SERVICE BULLETIN

July 2, 1987 M-950

SPORTSTER OIL FILTER MOUNT

Figure 1. Either

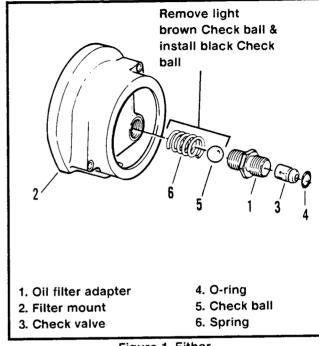
The purpose of this bulletin is to advise technicians of a potential problem. Some Sportster oil filter mounts with the new oil check ball may have an undersize oil passageway. The check ball could stick causing reduced oil pressure.

See Figure 1. Remove the light brown check ball (5). Install new (black) check ball (5).
